# Memorandum

**To** Queensland Floods Commission of Inquiry      **Date** 21 October 2011  
**From** Rory Nathan      **Project No** QE06544.01  
**Copy**  
**Subject** **Comment on Selected Issues Raised by WMAwater**

**Figure 1: Location of calibration points used to develop the RAFTS model in SKM (1998, 2004).**

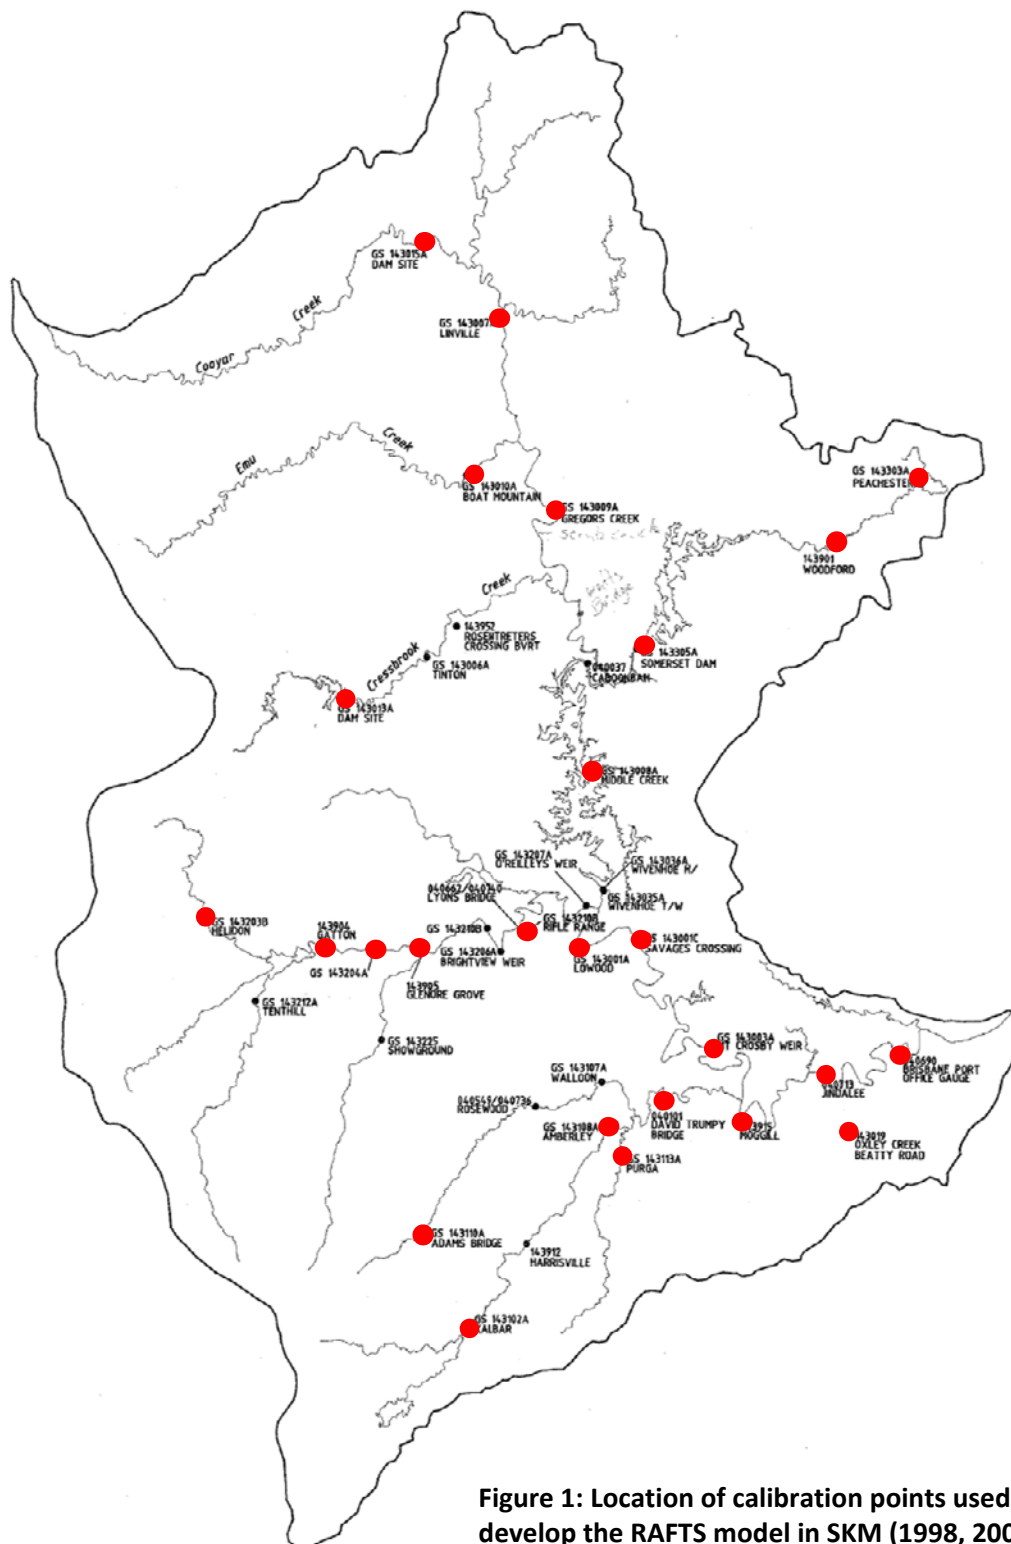
15. Mr Babister expresses "serious concern" that the only locations where the model estimates are reliable are downstream of these conceptual storages. The basis for this view is not clear, as reasonable comparisons of historic flood events with model simulations (in terms of peak, shape, and timing) were derived for a large number of sites at locations upstream of these nodes. The locations of these points of comparison are shown in Figure 1, and plots of model performance at these locations for the 1955 and 1974 events are provided in SKM (1998, 2004).
